QUALITY ASSURANCE -- NON-CONFORMANCE REPORT

Report No: NCR-000941

Reference Description: The joint fit-up of a PJP weld joint exceeded the allowable tolerance (Bikepath BK004A-061)

Job Name: SAS Superstructure

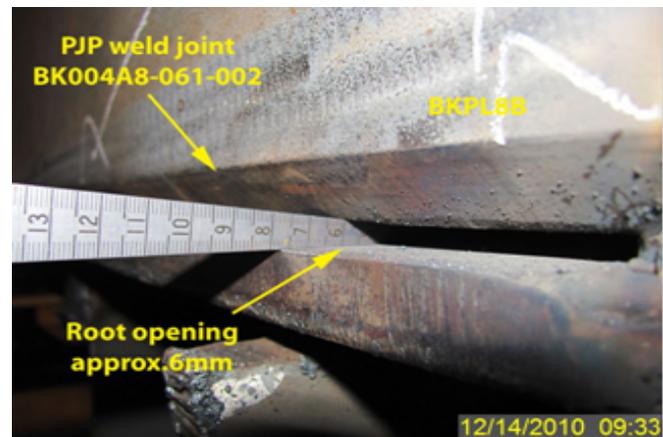
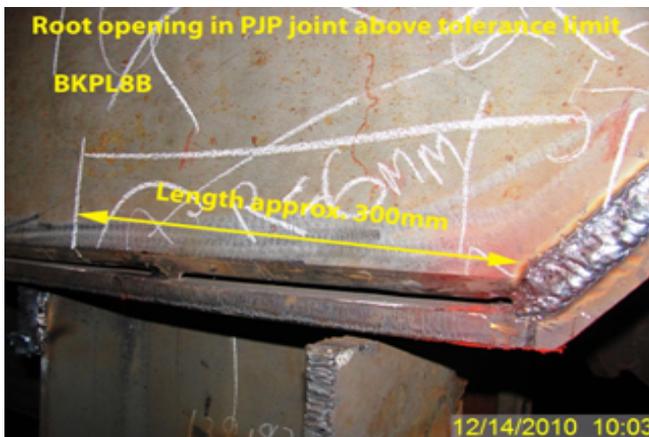
During a random visual inspection of Bikepath BK004A-061, the Quality Assurance (QA) Inspector observed excessive root openings on the PJP weld joint.

- Excessive root opening up to 6mm was observed on the Partial Joint Penetration (PJP).
- According to the approved drawing weld details and the approved WPS, the tolerance for root opening is 0mm (+3mm,-2mm for tolerance)
- The weld is identified as: BK004A8-061-002 corner weld, joining the Top Plate (BKPL2A) to Closure Plate (BKPL8B).
- The Y location of more root gap at 0 mm to 300 mm (Measuring from Side Plate BKPL3B).
- The Weld is a Partial Joint Penetration (PJP).
- The OBG Bike path is located at Bay #8.

AWS D1.5-2002 Section 3.3.2: The root opening between parts to be joined by PJP groove welds parallel to the member length (bearing joints excepted) shall be zero, or as small as practicable.

Passing NDT result does not show the "acceptability of this weld." Reference the recently submitted TC-RFI to accept this joint as fit-for-purpose.

-The weld is identified as: BK004A8-061-002 corner weld, joining the Top Plate (BKPL2A) to Closure Plate (BKPL8B).

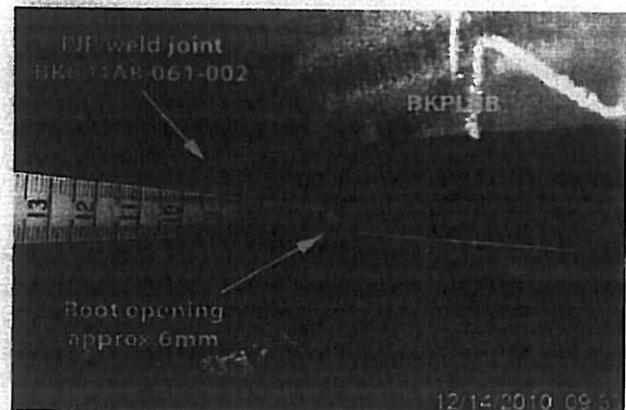
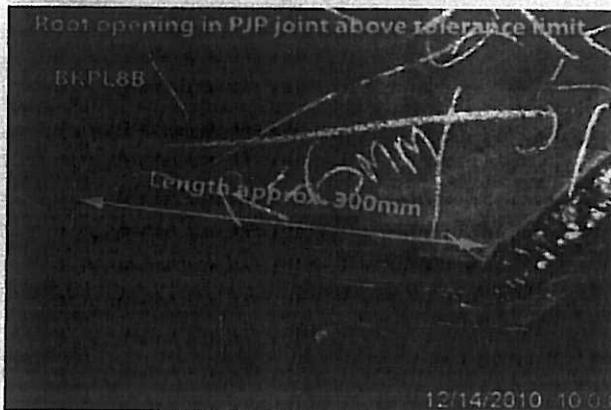
-Excessive root opening up to 6mm was observed on the Partial Joint Penetration (PJP).

-According to the approved drawing weld details and the approved WPS, the tolerance for root opening is 0mm (+3mm, -2mm for tolerance)

-The Y location of more root gap at 0 mm to 300 mm (Measuring from Side Plate BKPL3B).

This proposed resolution is acceptable. The documentation received is sufficient and the Department concurs that Non-Conformance ZPMC-0901 is closed.

The proposal to leave the 300mm of PJP weld as-built between BKPL2A and BKPL8B at BK04A-061 is acceptable on a fit-for-purpose basis.

-The weld is identified as: BK004A8-061-002 corner weld, joining the Top Plate (BKPL2A) to Closure Plate (BKPL8B).

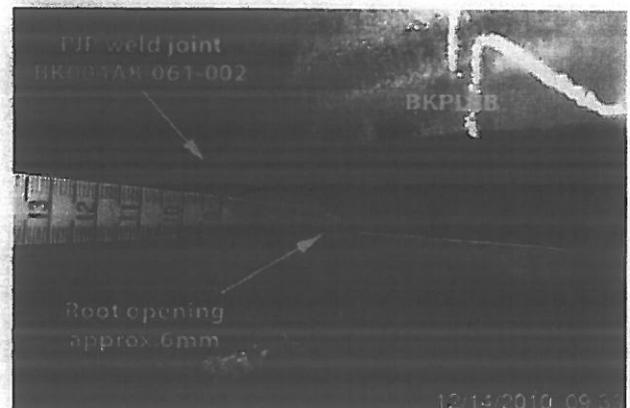
-Excessive root opening up to 6mm was observed on the Partial Joint Penetration (PJP).

-According to the approved drawing weld details and the approved WPS, the tolerance for root opening is 0mm (+3mm, -2mm for tolerance)

-The Y location of more root gap at 0 mm to 300 mm (Measuring from Side Plate BKPL3B).

Contractor left 300mm PJP weld between BKPL2A and BKPL5B as per RFI-ZPM-932 dated Jan 7, 2011. The weld has been accepted as fit-for-purpose. Contractor performed 100% MT and submitted test report confirming the weld is acceptable. The CWI involved was instructed to follow the requirements of the Welding Procedure.
